SOUTH TEXAS PROJECT, UNIT 2

AMENDMENT TO FACILITY OPERATING LICENSE

Amendment No. 106  
License No. NPF-80

ATTACHMENT TO LICENSE AMENDMENT NOS. 118 AND 106

FIGURE 3.4-4

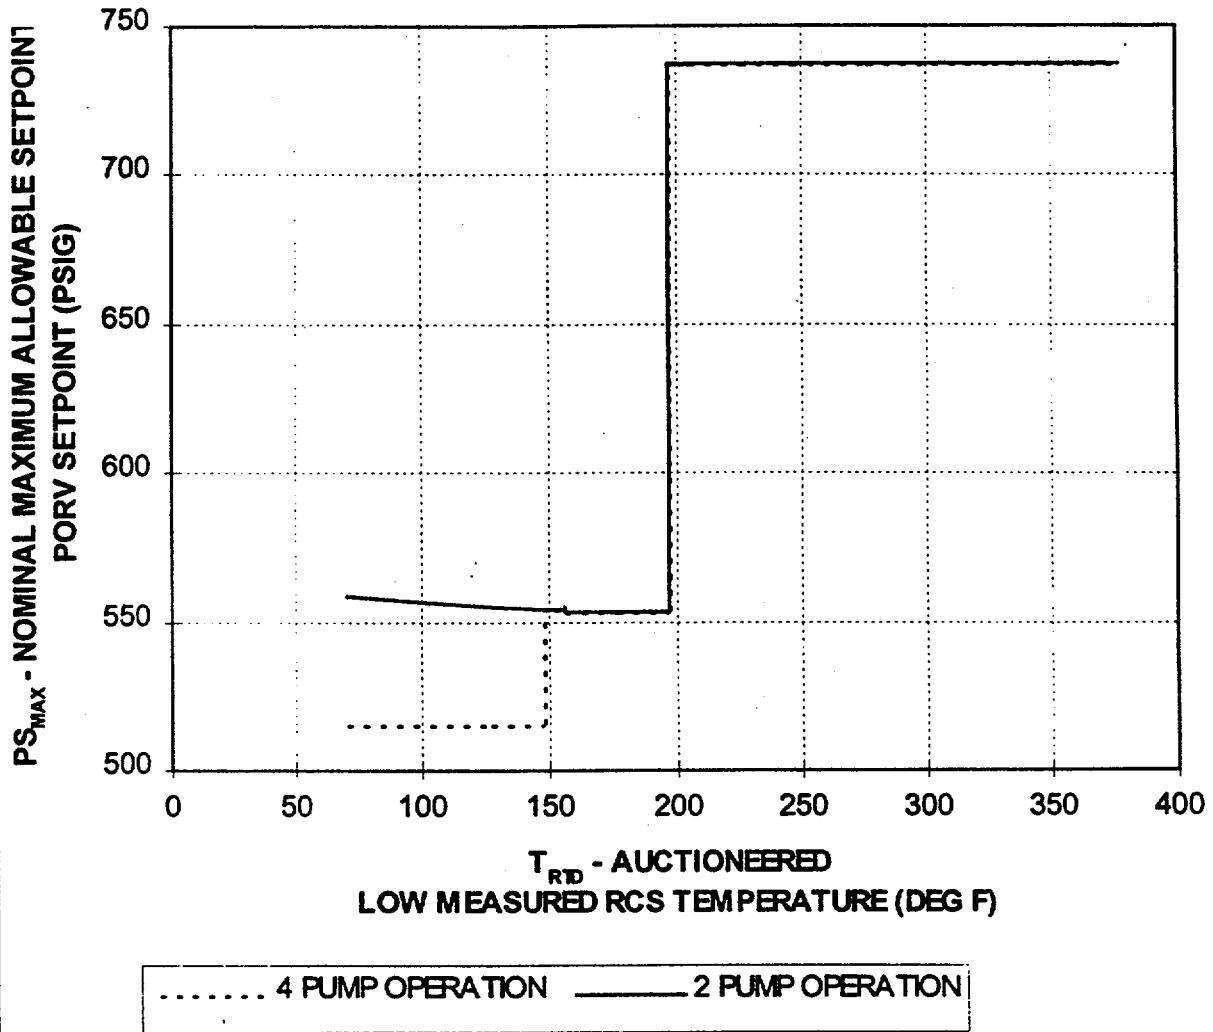
- a. Two power-operated relief valves (PORVs) with lift settings which do not exceed the limit established in Figure 3.4-4, or
- b. The Reactor Coolant System (RCS) depressurized with an RCS vent of greater than or equal to 2.0 square inches.
